Bulletin: CLIB-0001

Bulletin Type: Service

Topic: Idle Rattle in Heavy Duty Trucks

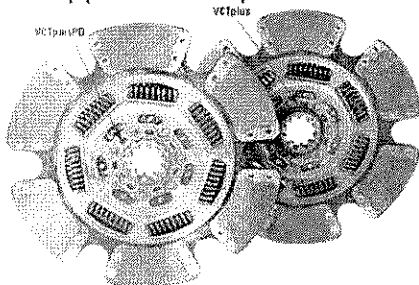
Eaton Clutch Division has developed the VCT Plus PD (pre-damper) clutch disc that has a special first stage in the damper, which is designed to isolate the engine idle pulsations before the pulsations reach the transmission. The pre-damper disc can be identified by the presence of 7 small springs around the hub.

- Implement the above corrective actions for problem resolution.
- If the customer chooses to just replace the original clutch discs with the VCT Plus PD discs, provide the following usage information.
 - Applications up to 1860 lb-ft – use disc part number 128716 (front & rear)
 - Applications from 1861 to 2050 lb-ft – use disc part number 128717 (front & rear)
 - Applications from 2051 to 2250 lb-ft – use disc part number 128718 (front & rear)
